HI-STORE

Chapter 2 & Environmental Report RSIs

- **RSI 2-5**

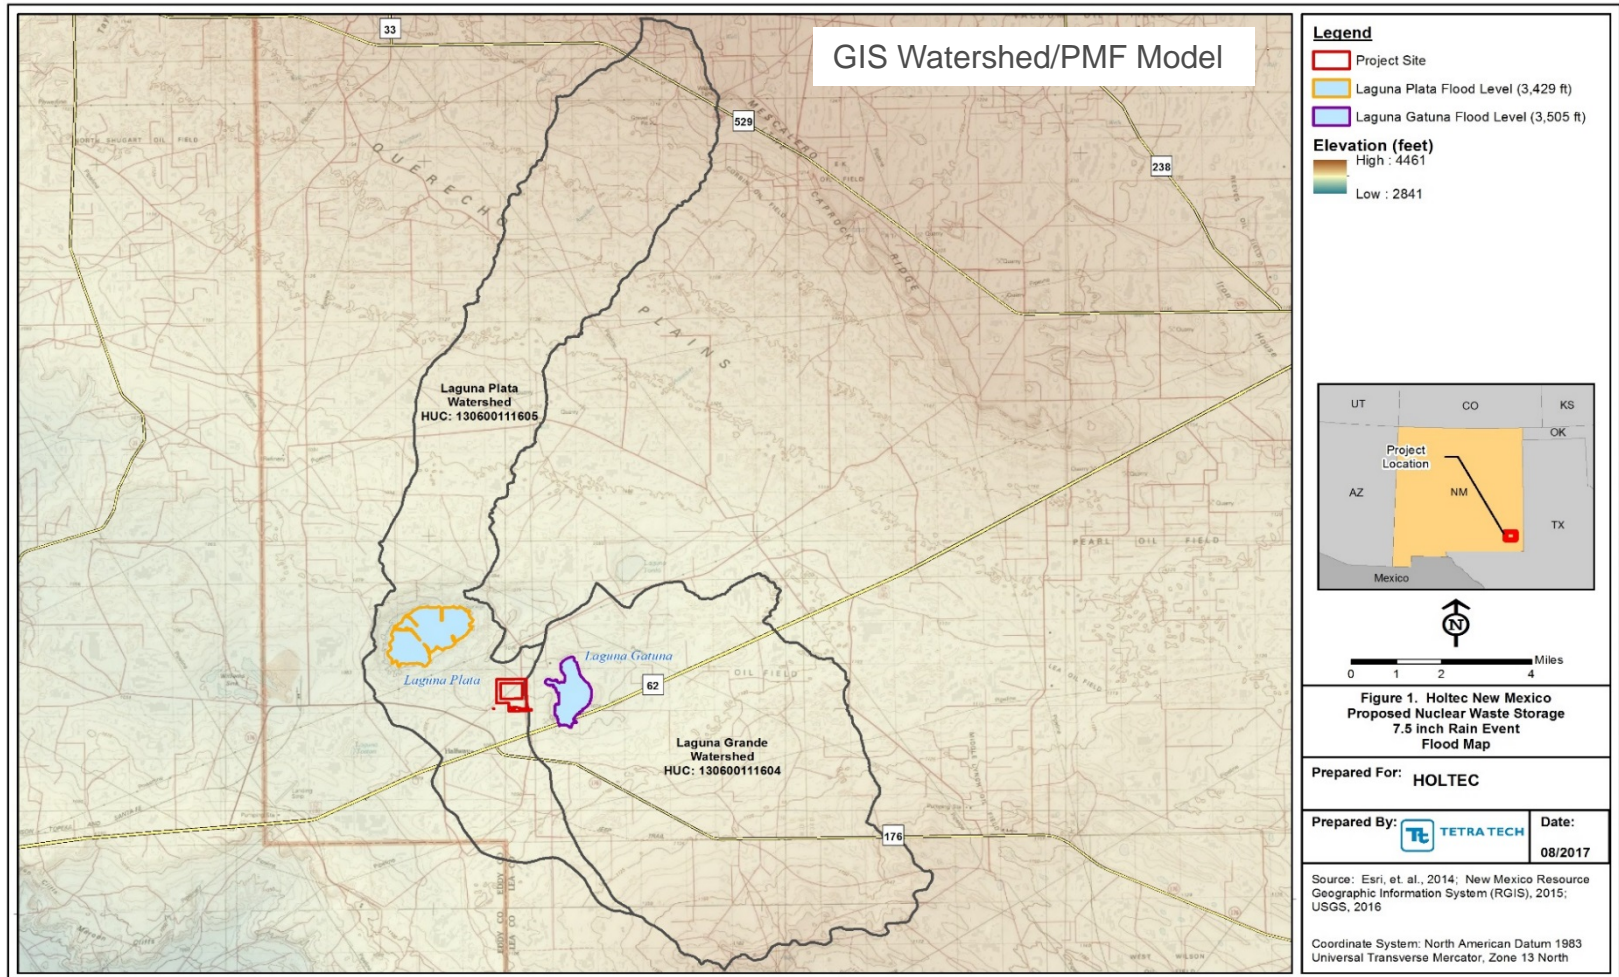
- Requested information includes:
 - Information describing hydrologic characteristics of the site.
- Strategies to respond
 - Additional data compiled from:
 - Federal Emergency Management Center Flood Map Service Center
 - State of New Mexico Interstate Stream Commission, Lea County Regional Water Plan 2016
 - U.S. Fish and Wildlife Service, National Wetlands Inventory
 - Western Regional Climate Center, Hobbs, Lea County Airport Data
 - Etc.

- **RSIs 2-9 & 2-10**

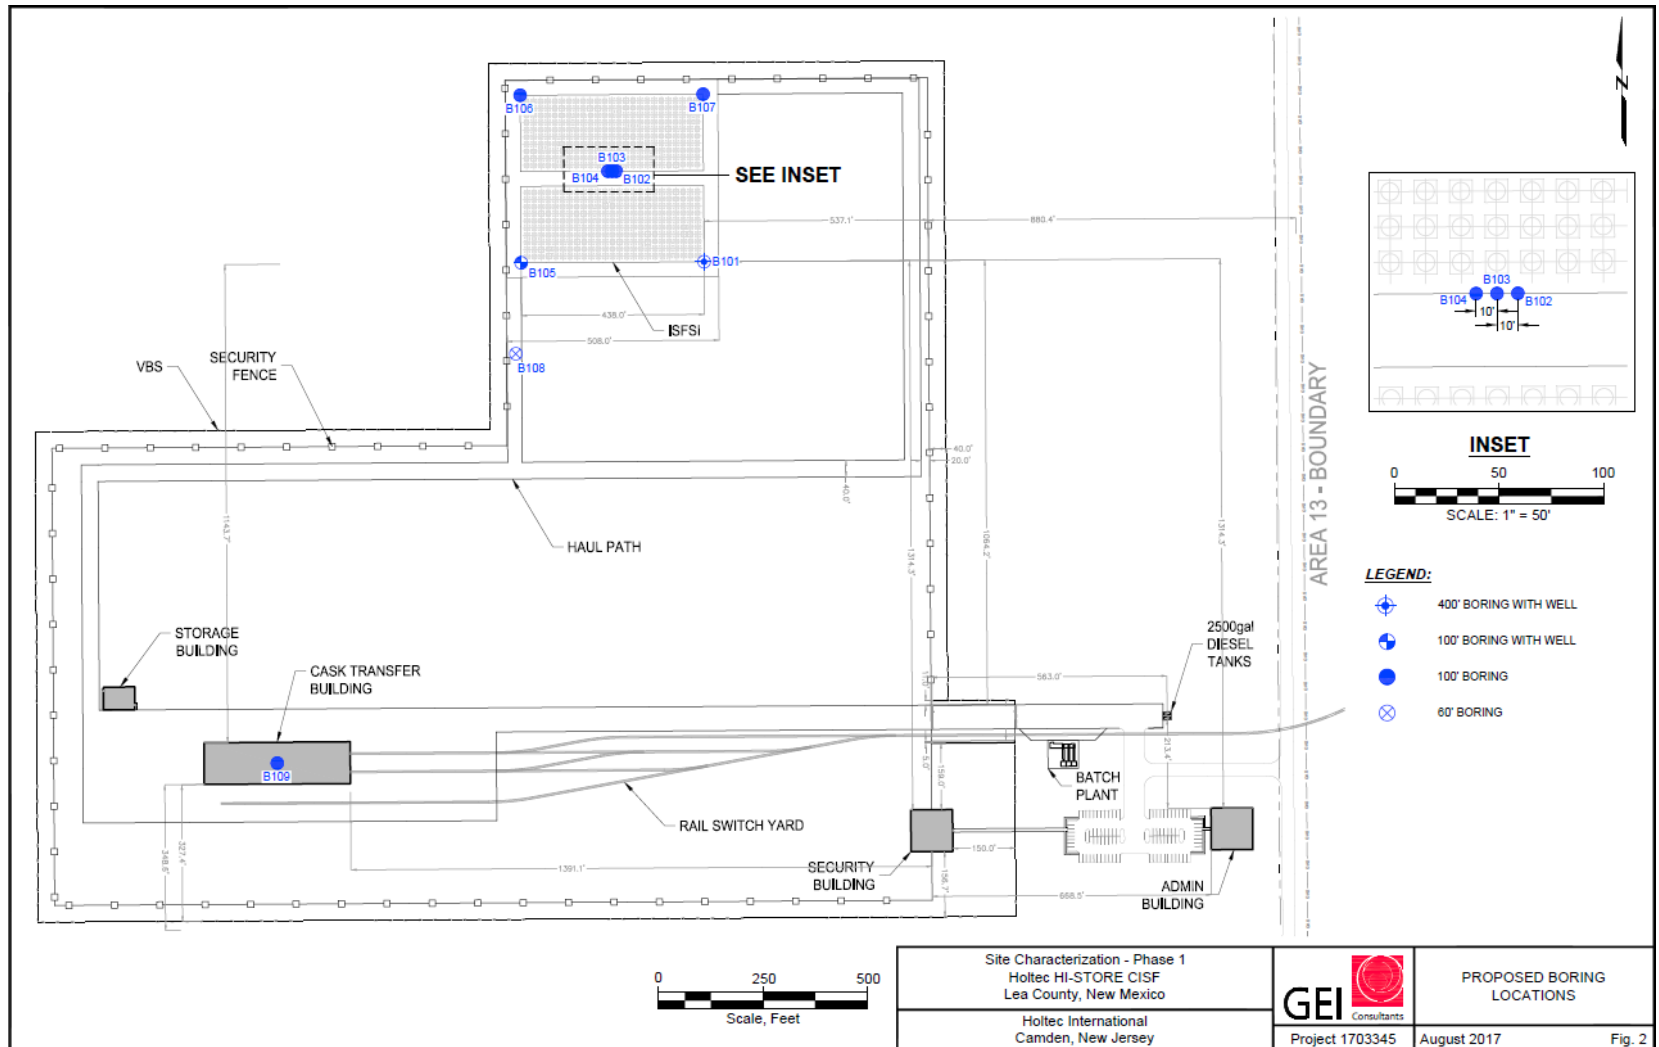
- Requested information includes:
 - Detailed characterization of site subsurface material
 - map of geotechnical exploration
 - Geological profiles
 - Groundwater mapping

- Strategies to respond
 - Boring plan generated using standard Holtec protocol
 - Protocol has been used at many other ISFSI sites (SONGS, BFN, CPS, WBN, Etc.)
 - 9 Standard Penetration Test (SPT) Borings
 - Cross-Hole Seismic Test
 - NUREG-1567 required laboratory testing
 - Groundwater observation wells
 - NUREG-0800 Section 3.2.7 COV values taken as 1
